September 22, 2022

City of Sebastopol  
Planning Department  
RE: Conditional Use Permit, 6782 Sebastopol Ave  
File: 2022-039

The Barlow has received your Incompleteness Letter in response to our Conditional Use Permit application for 6782 Sebastopol Avenue relating to our hotel proposal. The following letter includes responses to the outstanding questions posed by City staff.

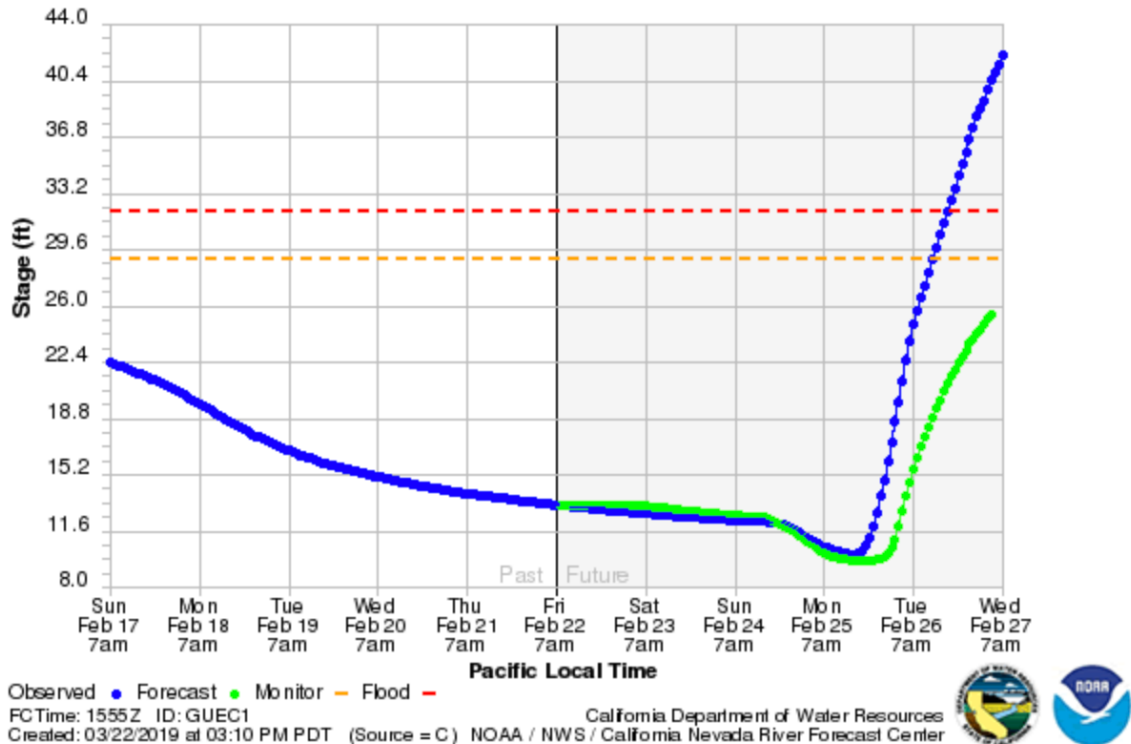
3. The proposed development is in a FEMA Regulatory Flood Zone area and what was approved when the original Barlow commercial development was approved may be different now, particularly for a hotel with 24-hour occupants and not just retail/commercial occupants. In addition, utility plans for water and sewer systems must be designed to minimize or eliminate infiltration of floodwaters in the systems as well as prevent discharges from the systems into floodwaters.

We understand that the issues listed in this part of the incompleteness letter are of concern and will be evaluated in the upcoming CEQA analysis. Thus, as stated, they do not constitute 'incomplete' application information. Please also note our additional information about parking, traffic, and flood issues provided in other responses herein.

On February 22, 2019, NOAA's river forecast center projected that the Russian River would crest up to 42 feet on Wednesday, February 27, the date in which The Barlow flooded. Had The Barlow understood how the Russian River flooding would translate at The Barlow campus and
